**RE: 5179 Golondrina NW
Grading and Drainage Plan
Engineer's Stamp Date: 05/25/2026
Hydrology File: F11D005A
Case # HYDR-2026-00062**

Based upon the information provided in your submittal received 03/13/2026, the Grading and Drainage Plan is approved for Grading Permit and Building Permit. Please attach a copy of this approved plan in the construction sets for Building Permit processing along with a copy of this letter.

ENGINEER'S SEAL	114 AMENDED TRINITY RANCH ADDITION 5179 GOLONDRINA NW GRADING AND DRAINAGE PLAN	DRAWN BY MM
		DATE 2-24-2026
3/12/26	ALBUQUERQUE, NM 87199 (505) 321-8099	SHEET # C1
DAVID SOULE P.E. #14522		JOB #

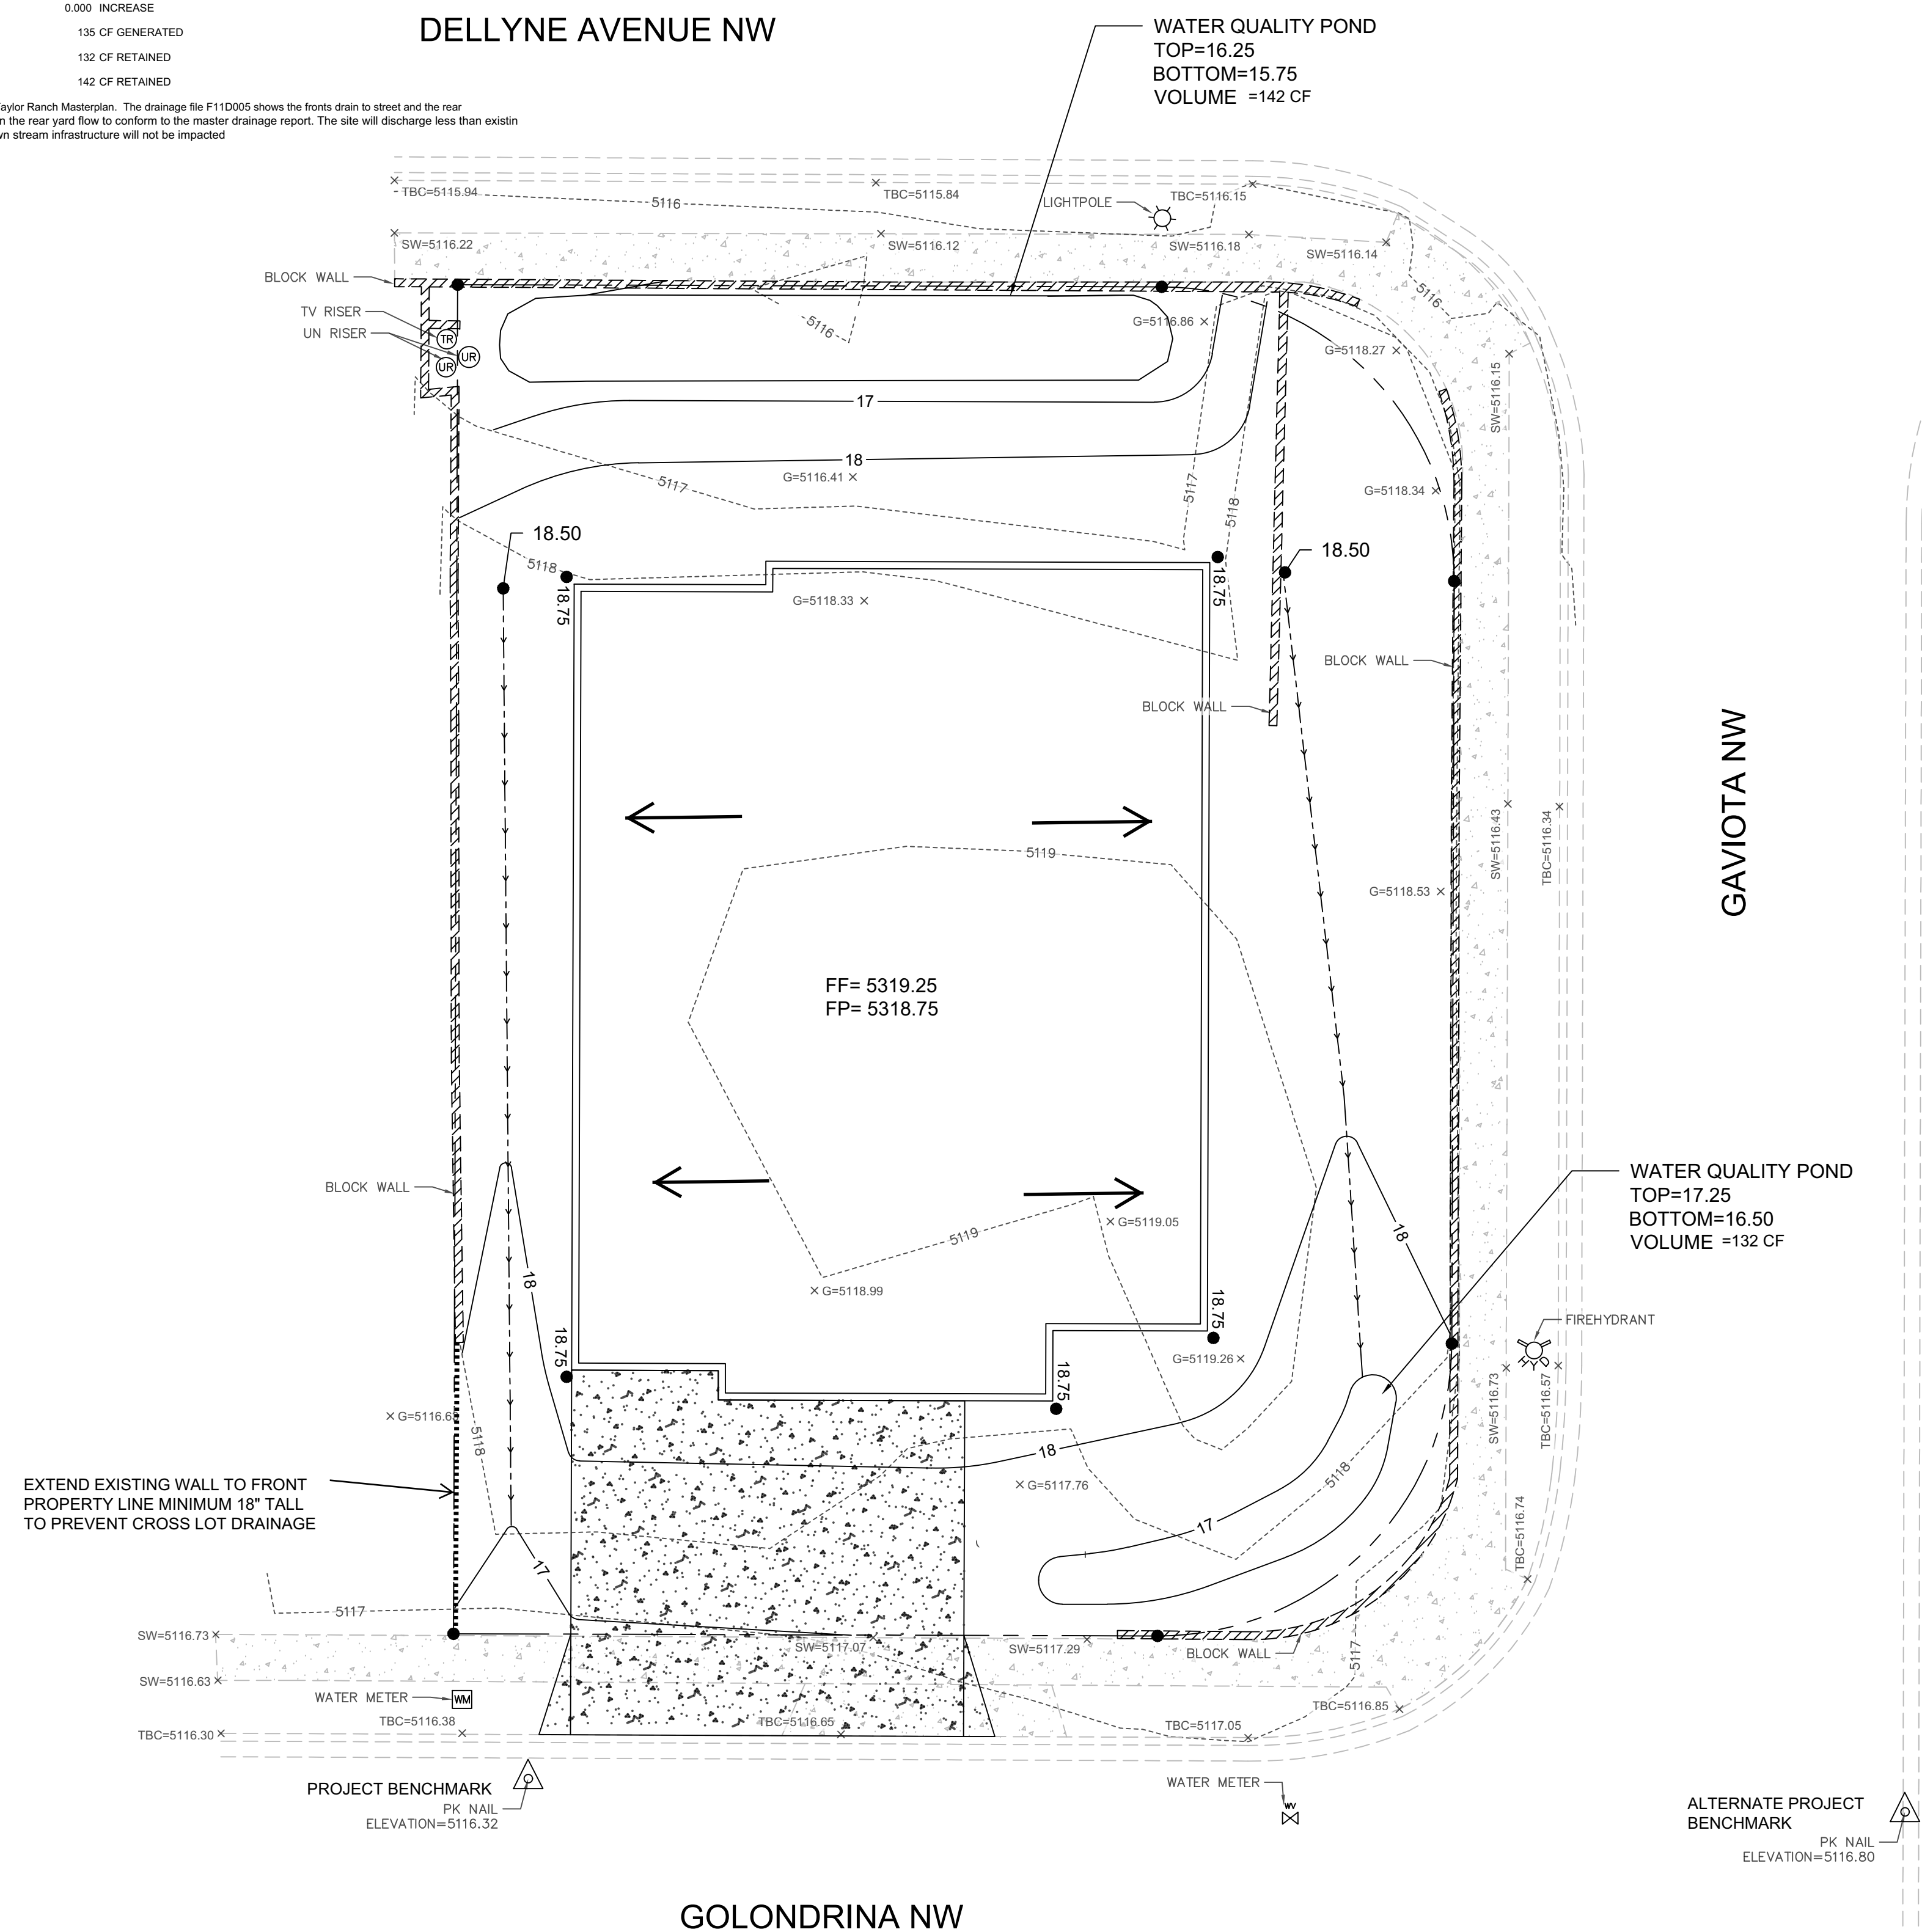
1. Engineer's Certification, per the DPM Part 6-14 (F): Engineer's Certification Checklist for Non-Subdivision is required.
2. Please provide the Drainage Covenant with Exhibit A for the stormwater quality ponds per Article 6-15(C) of the DPM prior to Permanent Release of Occupancy. Please submit the original copies along with the **\$ 25.00** recording fee check made payable to Bernalillo County to the Hydrology Section of Development Review Services on the Ground floor of Plaza de Sol. Submittal in ABQ-PLAN is also required.
